SERVICE BULLETIN

NUMBER 124

SUBJECT: PA-22 Landing Gear

MODELS AFFECTED: All Model PA-22 Airplanes

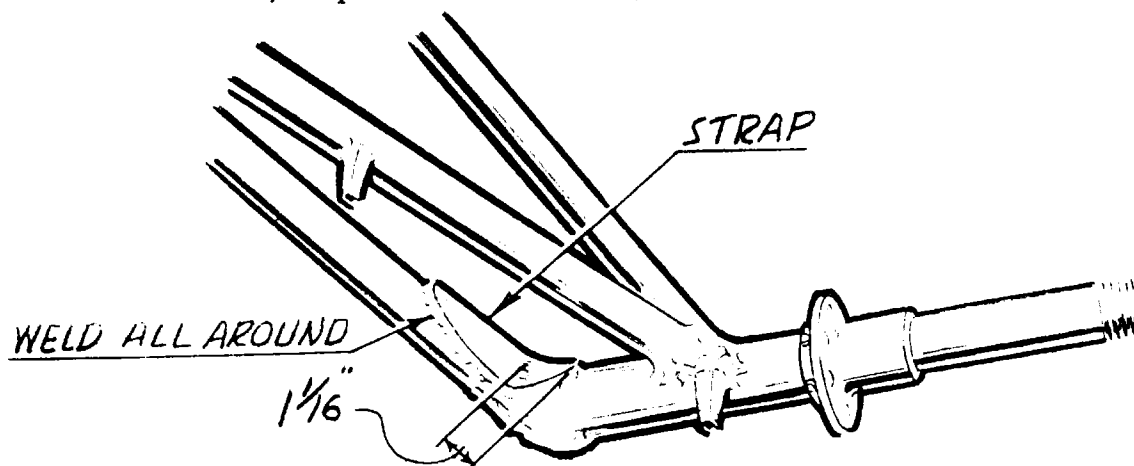
A number of field service reports have been received to the effect that cracks have been appearing in the leading edge of the streamlined tube of the PA-22 landing gears at a point where it joins the inboard end of the axle.

Indications are that this is a fatigue failure and it is requested that all Model PA-22 airplanes listed above be modified by installing a reinforcing strap, part number 14415-00, as per the sketch below.

The reinforcement strap can be obtained from the Service Department of the Piper Aircraft Corporation, free of charge.
